**Reference** 24/2057/VAR

**Location** Chestnuts 65 Salterton Road Exmouth EX8 2EJ

**Proposal** Variation of condition 2 (approved plans) of planning permission 23/0538/FUL (Construction of ground floor and first floor extensions to create an additional 10 additional HMO bedrooms, creation of new vehicular access onto Salterton Road and provision of parking to the front of the site) and condition 10 (parking layout) to allow the removal of east elevation chimney and alteration to approved windows on eastern elevation, the addition of ensuites at 1st floor, change to material finishes, re-positioning of bike and bin store, change to parking layout and retention of disability ramp, retention of front West wing roof and inclusion of 2no roof lights.

<b>Committee Date: 21.04.2026</b>
<b>Exmouth Littleham (Exmouth)</b>	<b>24/2057/VAR</b>	<b>Target Date: 30.12.2024</b>
<b>Applicant:</b>	<b>Mr David Crocker</b>	
<b>Location:</b>	<b>Chestnuts 65 Salterton Road</b>	
<b>Proposal:</b>	<b>Variation of condition 2 (approved plans) of planning permission 23/0538/FUL (Construction of ground floor and first floor extensions to create an additional 10 additional HMO bedrooms, creation of new veh

East elevation as approved under 23/0538/FUL

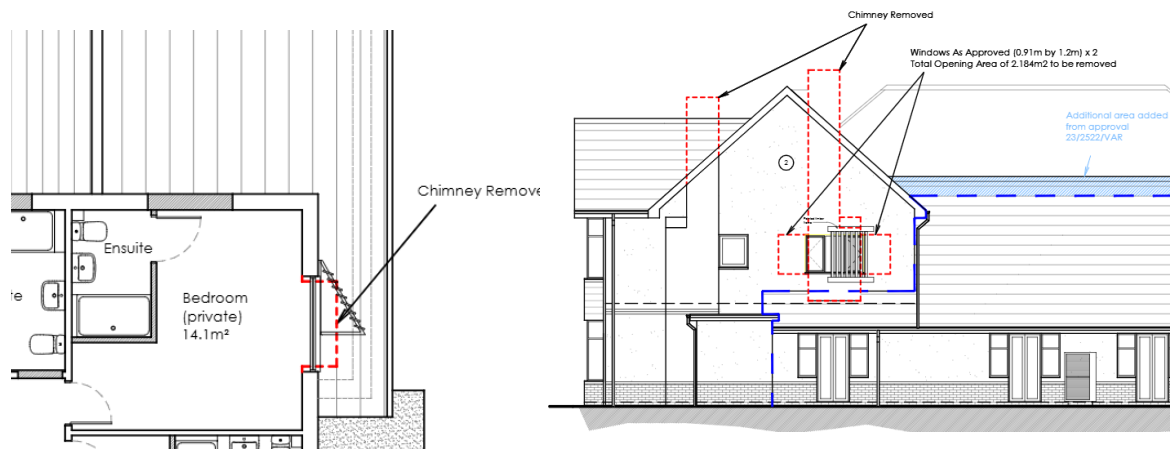
The original approval indicated two vertical windows either side of the existing chimney breast. The windows relate to a private bedroom within the dwelling and are the only source of light to the room as the former north facing windows have been blocked up to allow for the rear extension.

No changes were made to this arrangement in the later 23/2522/VAR application. This application seeks to regularise the works undertaken whereby the chimney breast has been removed and a single window has been installed in lieu of the approval scheme.

The approved windows had a total area of 2.18 square metres (1.09sqm per window). The location of the chimney breast would have prevented overlooking of the adjacent neighbour from the left hand window.

The window as built has area of 1.92sqm. The submitted louvre screen has been proposed to prevent overlooking from the window into the neighbour's garden at No. 67 Salterton Road. A condition would be imposed upon any approval requiring the screen to be installed within three months of the date of the approval and requiring a screen to be retained in perpetuity in the interests of privacy and to reduce the impacts to the neighbouring garden at No. 67 Salterton Road. The above option (drawing no. 8601-02 Rev P) is the preferred option referred to in comments received from the neighbour.

The Town Council have objected to the proposed screen on the grounds that the design would be out of keeping, and that no changes to the originally approved window design should be permitted. However, the chimney breast which previously provided some screening has been removed and the proposal represents a pragmatic solution to prevent overlooking of the neighbour's garden. The proposed screen extends 800mm out from the east elevation but would be partially screened by the second chimney breast to the south of the east elevation which has only been removed down to eaves level. The screen would be set 7 metres back from the principal elevation and would therefore be unlikely to have a harmful impact upon the street scene.

12. The proposed louvre screen as shown on drawing no.s 8601-02 Rev P Proposed Floor Plans, 8601-15 Window Surround and 8601-04 Rev. P Proposed Elevations shall be installed within three months of the date of this approval and the screen shall be maintained and retained as such in perpetuity.
